INDESIT company

Model type:
WP62EX

Commercial code:
F027760

n1040251: Induction motors NO On/Off switch

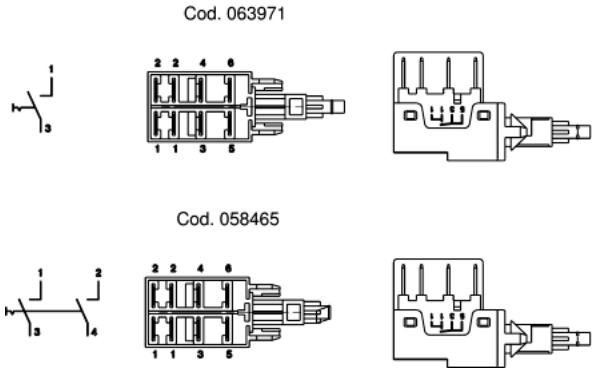
From serial number 20304.0001, the NO On/Off switch code 063971 replaces the NO + NO double On/Off switch code 058465 on all the washing machines with induction motor produced in the Teverola factory.
Both switches are regularly managed, therefore in case of repair the serial number of the unit must be taken into consideration.

FIG. 1

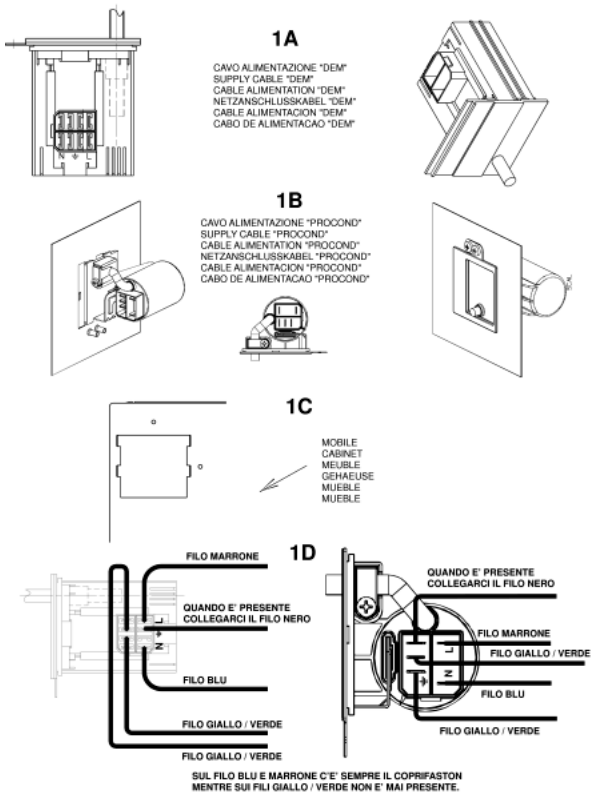
All appliances produced in the Comunanza (from serial no. 21008.0001), Teverola (from serial no. 21111.0001) and Brembate (from serial no. 21119.0001) factories have been equipped with power supply cables with integrally moulded filter (see fig.1 - 1A and 1B) and new units having a specific opening at the back for fixing the new cables (see fig. 1 - 1C).
The new units, together with the new cables, can be used in place of the premodification ones, by connecting the wiring to the cable, as shown in figure 1 - 1D.
The codes of the new units and of those replaced (ESI - table n1040276fig02), which will be managed until stocks run out, are given below.

IMPORTANT: the fixing / continuity screw is a specific self-scraping screw (code 092348) that ensures earth continuity between the filter and the unit. The same screw must be refitted in order to guarantee machine conformity.

The premodification wirings, are also managed for modified products by making the connection to the terminal block of the new cable as shown in fig. 1 - 1D.
The wiring diagrams given in the Documentation remain unchanged.

The new power supply cables are:
Code 091632 - Power supply cable 3x1 schuko 1.5m+capacitance filter;
Code 091633 - Power supply cable 3x1 schuko 1.5m+inductive filter;
Code 091634 - Power supply cable UK 3x1 l= 1950mm + inductive filter;
Code 091635 - Power supply cable UK 3x1 l=1950mm+capacitance filter;
Code 091636 - Power supply cable l=2.55m AUS+inductive filter;
Code 091641 - Power supply cable l=2550mm AG +capacitance filter;
Code 091642 - Power supply cable 1.85mt SHUKO no inductive filter;
Code 091643 - Power supply cable 3x1 (CH) 1.5m+inductive filter;
Code 091645 - Power supply cable 3450mm SOUTH AF.+capacitance filter;
Code 091690 - Power supply cable shuko l2.55m KOREA+inductive filter;
Code 091689 - Power Supply cable l=2550mm AG+inductive filter.

n1040279: Heater retaining element bracket and counterweight fixing

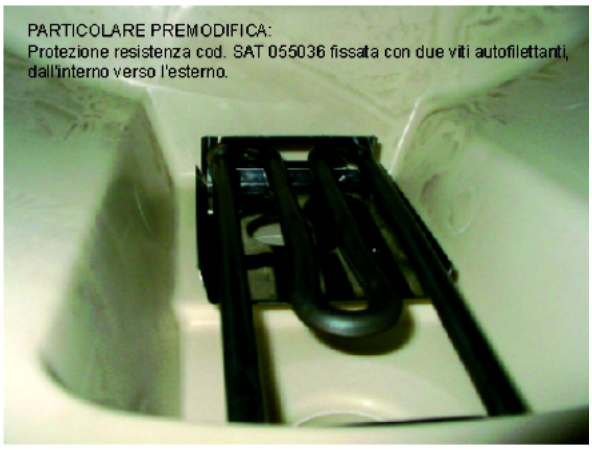
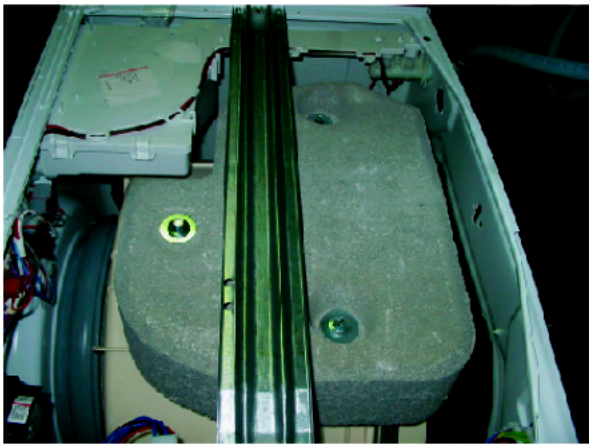
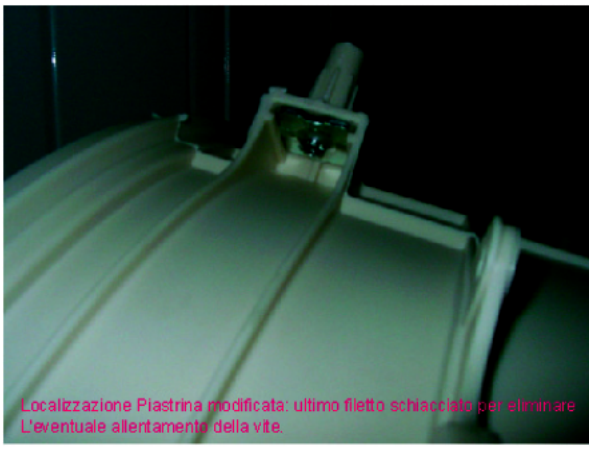
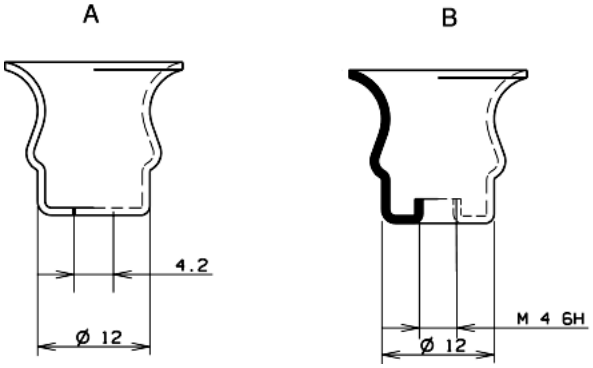
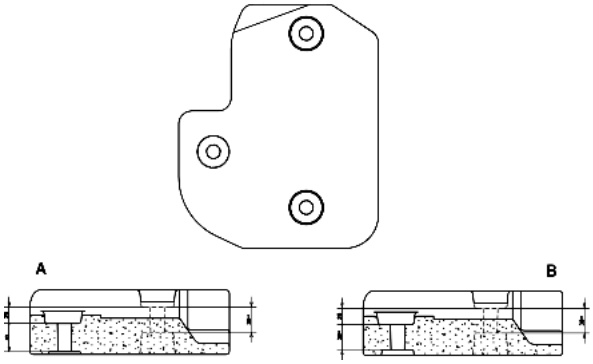
From serial no. 21015.001, a heater retaining element bracket (see fig.3) has replaced the heater retaining element protection Sat code 055036 (see fig.4) on all plastic tanks installed in washing machines produced in the Teverola factory.

The new part (fig. 1A) is fixed to the bowl with a self-tapping screw from the inside outwards and differs from the one used in the Comunanza factory (fig. 1B) in the fixing hole which is not threaded.
In order to reduce the number of parts used, only kit 058523 is managed and which, if used on the Teverola washing machines, must be fixed with a self-tapping screw, instead of metric, after widening the tapped hole with a suitable drill bit.
When inserting the heater retaining element, particular care must be taken so that it is fitted correctly (Fig. 3).
The plastic tanks to be arranged for the guide have the same Sat code as those with the protection.

>From serial no. 21121.0001, the counterweight Fig. 2B with outlet increased by 5 mm in the centre has replaced the previous counterweight Fig. 2A.
The new counterweight (fig. 5) is fixed using three M8 X 63 mm screws with washer code 092016 (see fig. 8) and three plates with the last thread flattened (fig. 6) to prevent accidental loosening of the screw.
All the plates code 055038 in stock in the Centralised Warehouse have been replaced and can also be used on premodification appliances.
The modified counterweight has the same Sat code as the premodification item (066615) that will be managed until stocks run out.
The new counterweight must be assembled using the new screws and plates (see fig. 7).
Both counterweights can be employed necessarily using the following fixing parts which are specific for each type of counterweight:

Fixing parts for premodification counterweight (see fig. 9):
3 pieces code 055019 - Screw M8 X60 mm;
3 pieces code 055018 - Conical washer;
3 pieces code 034336 - Flat washer;

Fixing items for modified counterweight:
3 pieces code 092016 - Screw M8 X 63 mm with washer;
3 pieces code 055038 - Plate with last thread flattened;

FIG. n1040305fig01

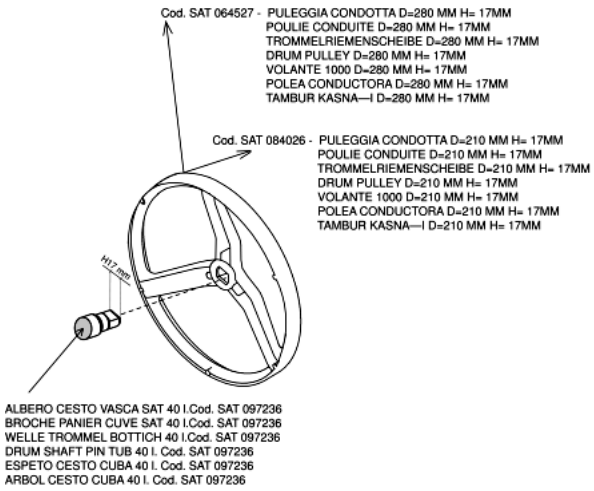
·Eeproms - The new software for the 40 litre EVO washing machines can also be used on premodification appliances; it is managed with the same Sat codes as the previous software, which is being immediately replaced as the new models enter into production.
·Pulleys - The use of a single 40 litre bowl assembly in Assistance involves management of the pulleys used in production (097268 and 097267) and also those required for creating the various combinations (see fig. n1040305fig.01):

NB: From serial no. 31103.0001, all EVO appliances are equipped with a 40 litre bowl with H=15 mm drum cross shaft which will be managed with the same SAT code (097236) as the 40 litre bowl with H=17 mm shaft until stocks last.
To create the various combinations, the following pulleys are required:

Code 064527 - Pulley D=280mm H=17 mm;
Code 084026 - Pulley D=210mm H=17mm.

Code 097268 - Pulley D=280mm H=15 mm;
Code 097267 - Pulley D=210mm H=15mm.
Exceptions to this are models W93UK (23330) and W103UK (23334) which are equipped with a 46 litre bowl; therefore if the bowl needs replacing code 096198 with 20 mm pulley cross shaft must be used.
In production, pulley code 064527 (diameter D= 280 mm and central hole H= 17mm) is used; therefore, when replacing the bowl, code 097269 (diameter D= 280 mm and central hole H= 20mm) must be used.
